**ADDENDUM
NO. 3**

November 6, 2023

**HANOVER COMMUNITY SCHOOLS - JANE BALL ELEMENTARY
RENOVATIONS AND HIGH SCHOOL IMPROVEMENTS**

Addendum Two (AD.03) to the drawings and specifications prepared by Gibraltar Design for **Hanover CSC – Jane Ball ES Renovation and HS Improvements** for Hanover Community School Corporation, Cedar Lake, Indiana.

© GIBRALTAR DESIGN SHEET
JB A-301

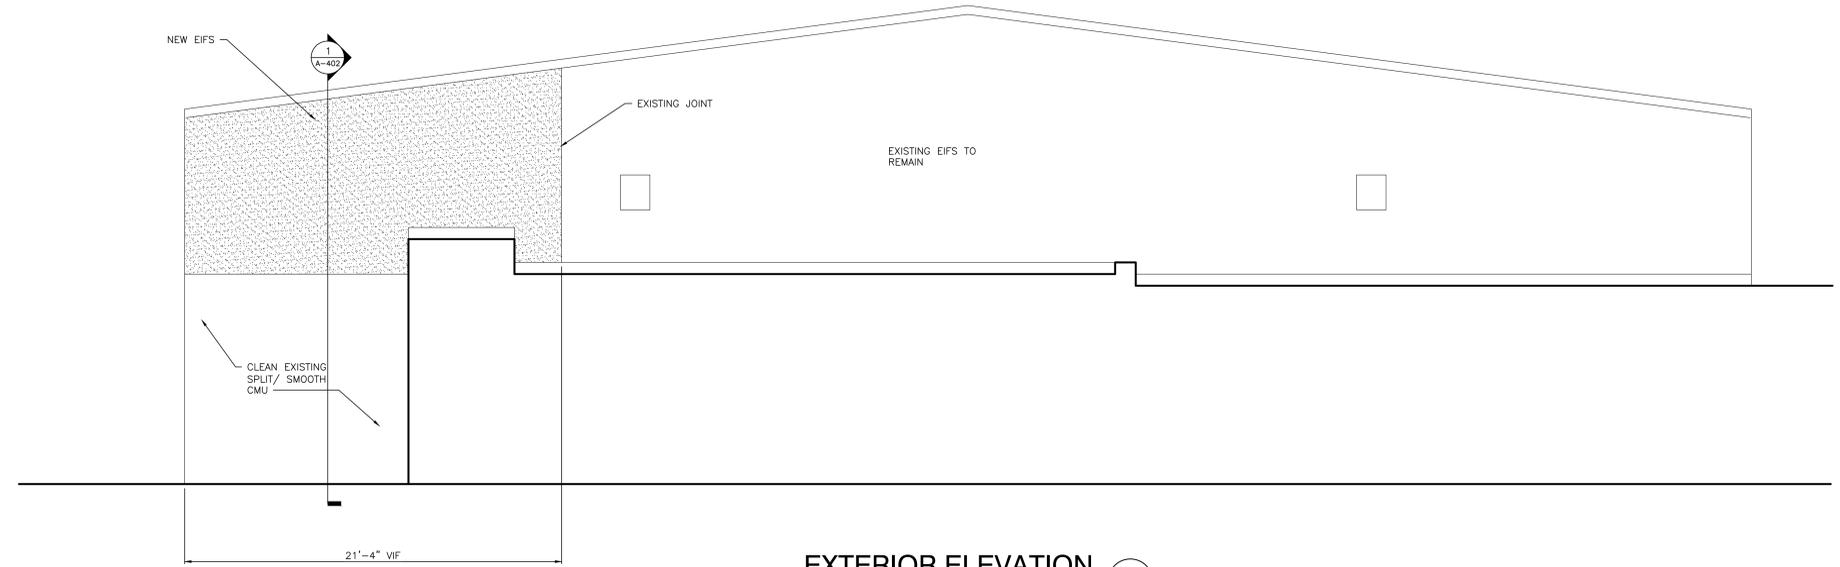
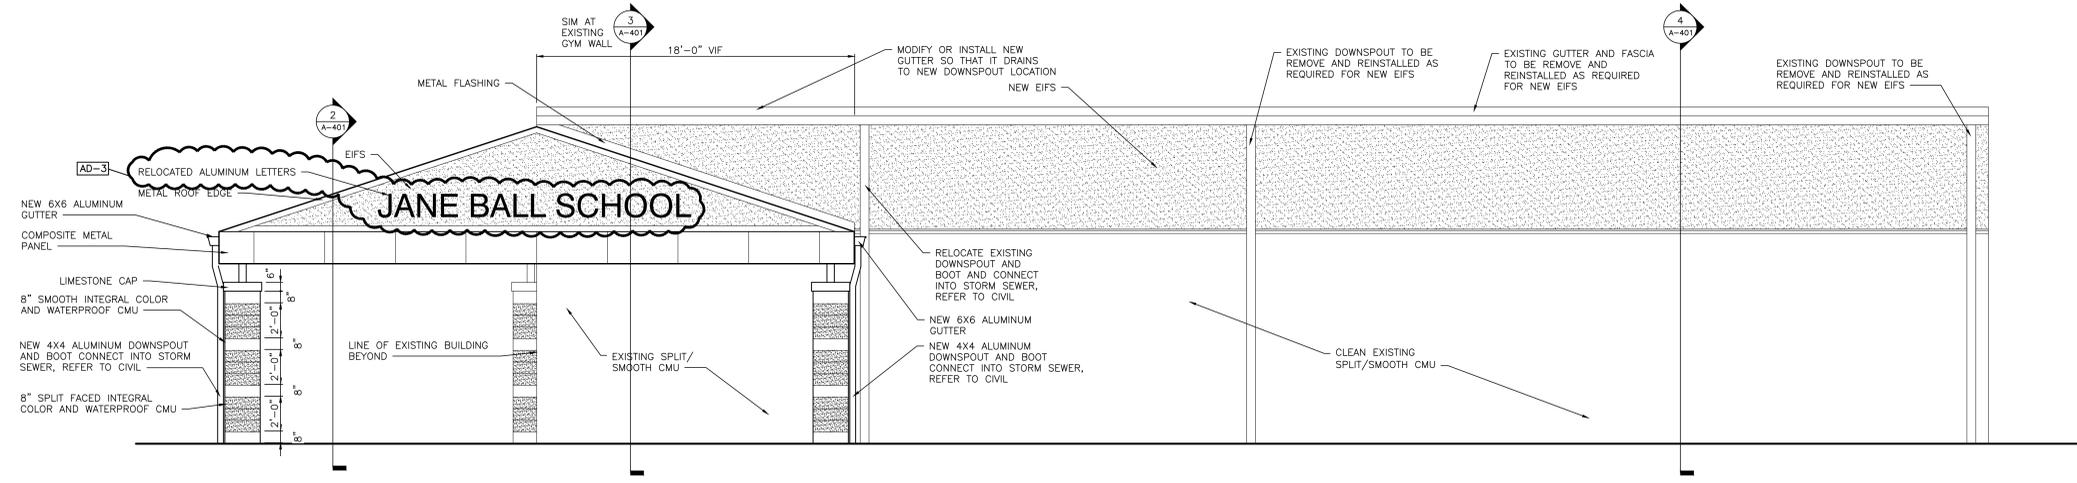
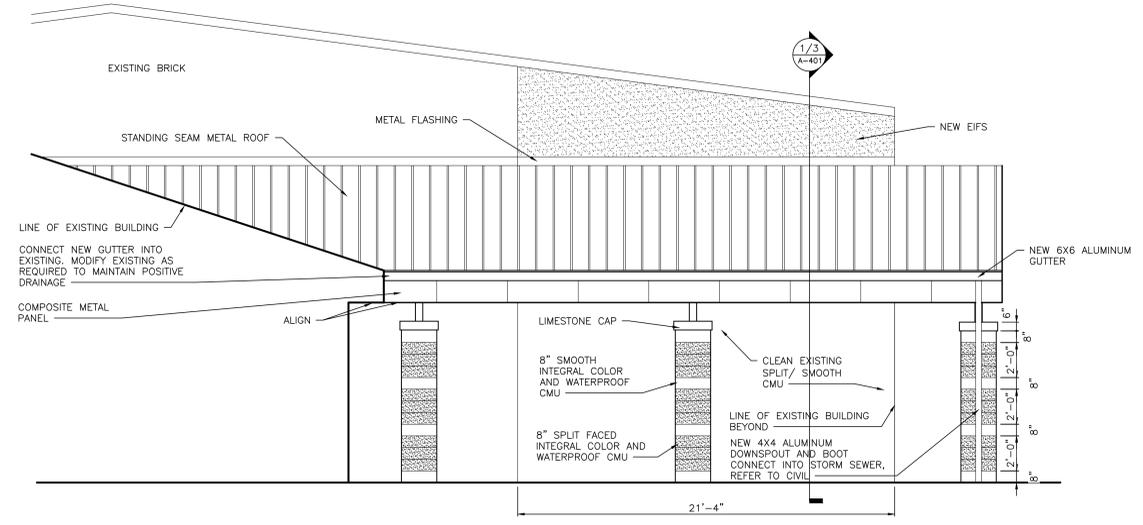
Reference Exterior Elevations; The **Bid Category No. 1 Contractor** is responsible for relocating the existing aluminum lettering as indicated on the construction documents.

19. Sheet A-301

- A. Refer to revised full-size drawing, included in this Addendum for the location of the relocated Aluminum Letters.

GIBRALTAR DESIGN SHEET
JB M-102

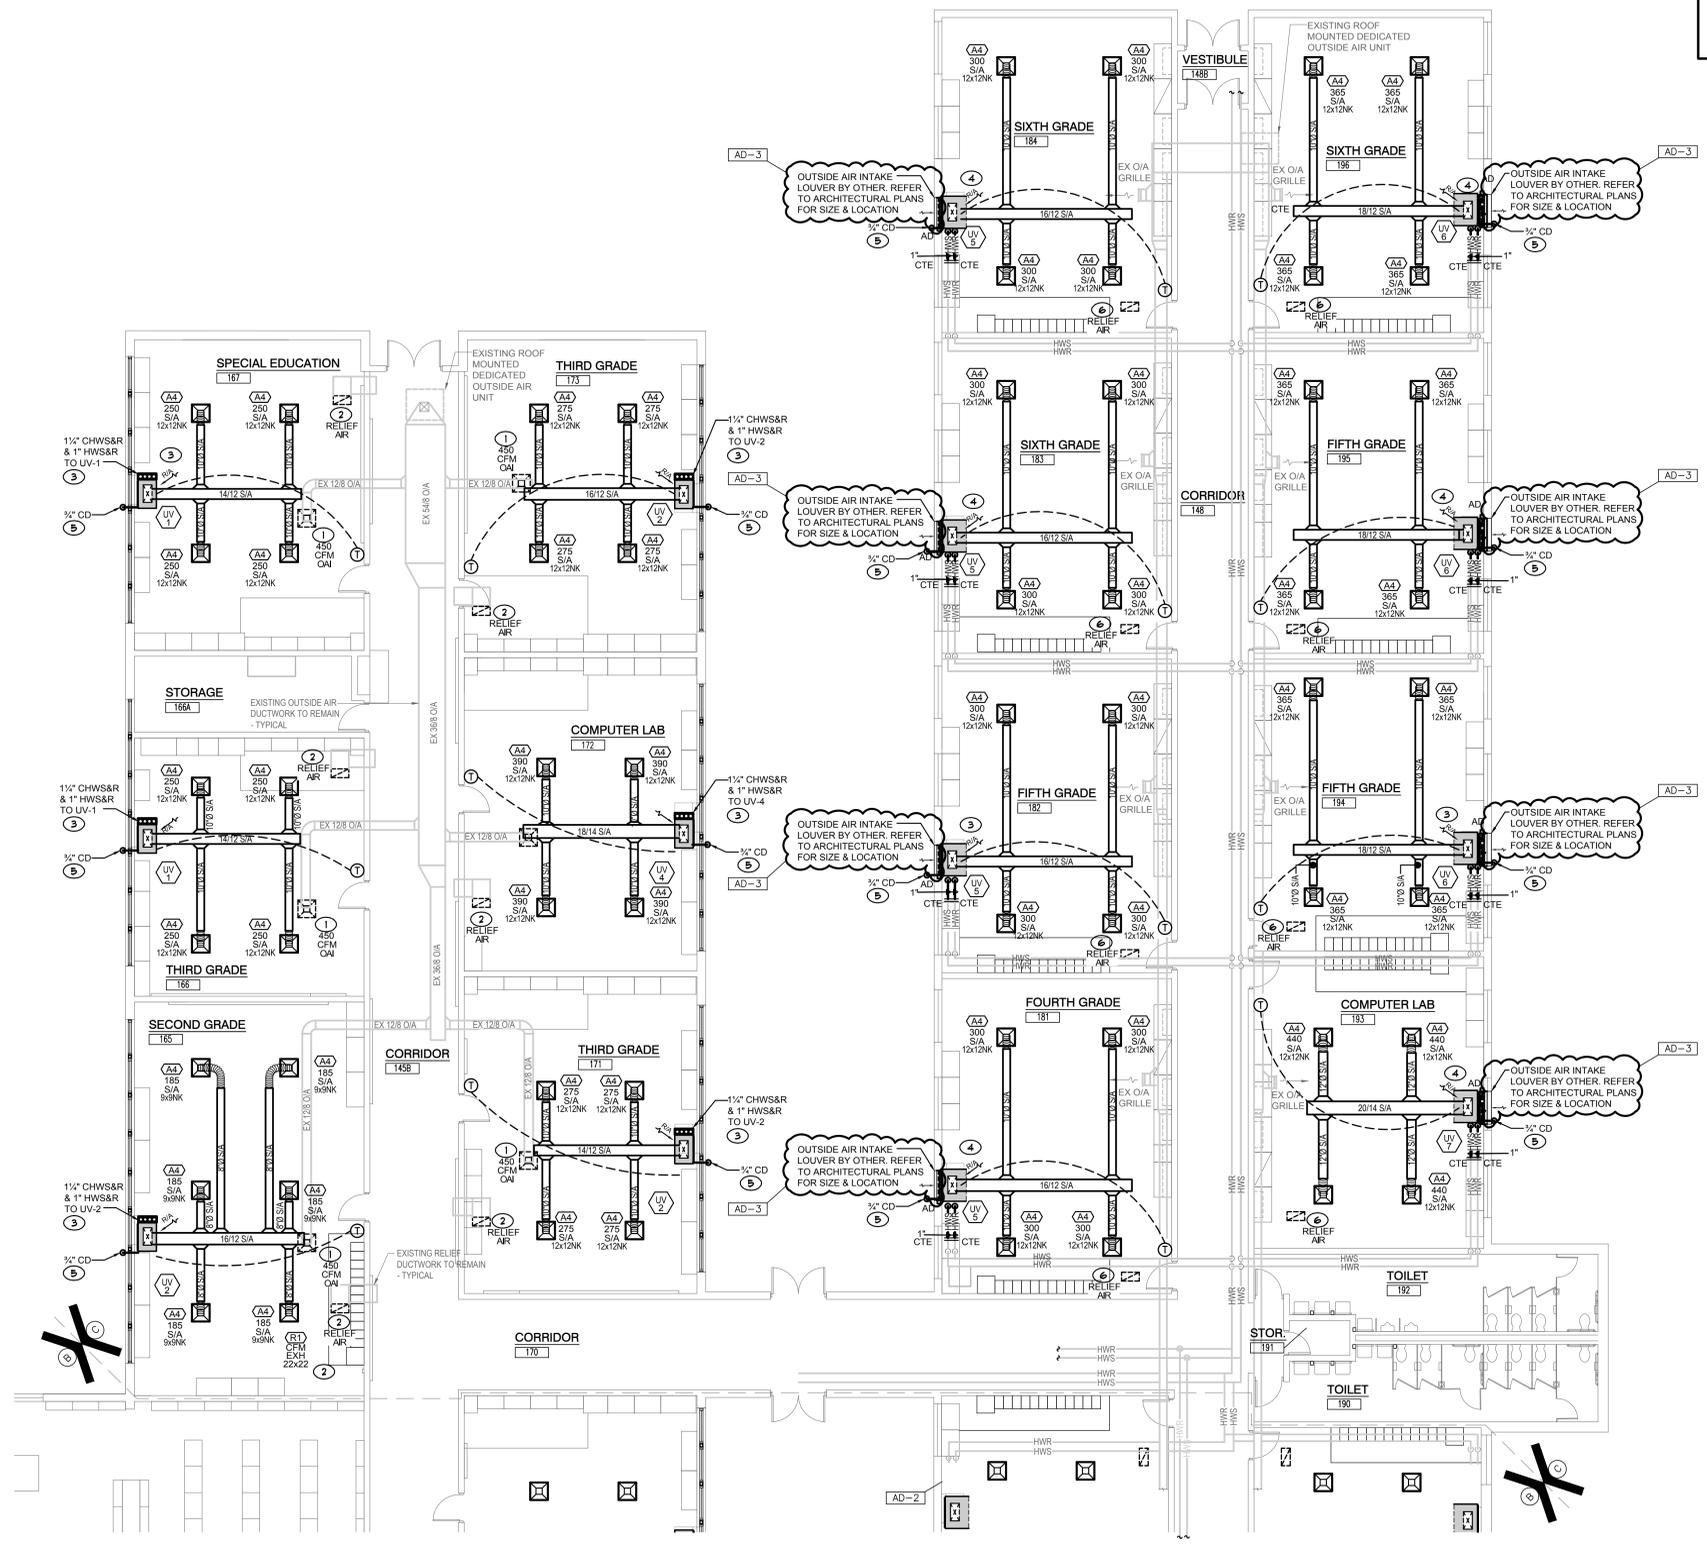
20. Sheet M-102 & M-103

- A. Refer to revised full-size drawing, included in this Addendum for the following revisions.
 1. Remove louver LV-1 and LV-2 tag from self-contained units.
 2. Revise Sheet Note 5.

GIBRALTAR DESIGN SHEET
HS P110

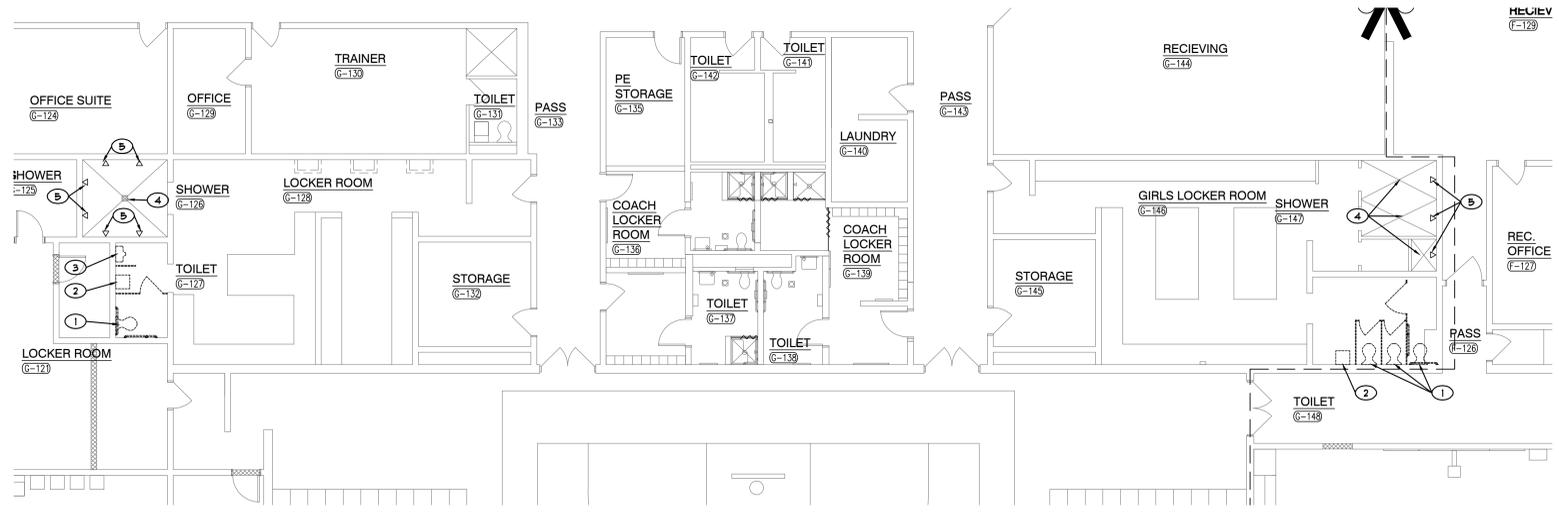
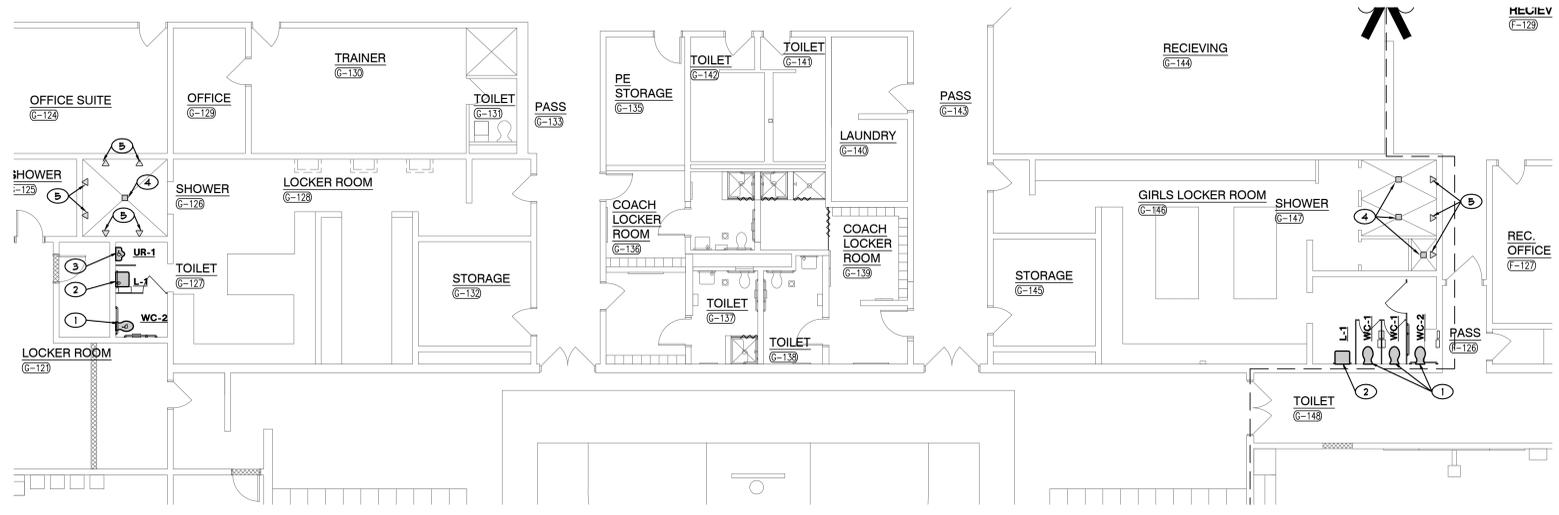
23. Sheet P-110

- A. Refer to revised full-size drawing, included in this Addendum for revisions to the shower fixture.
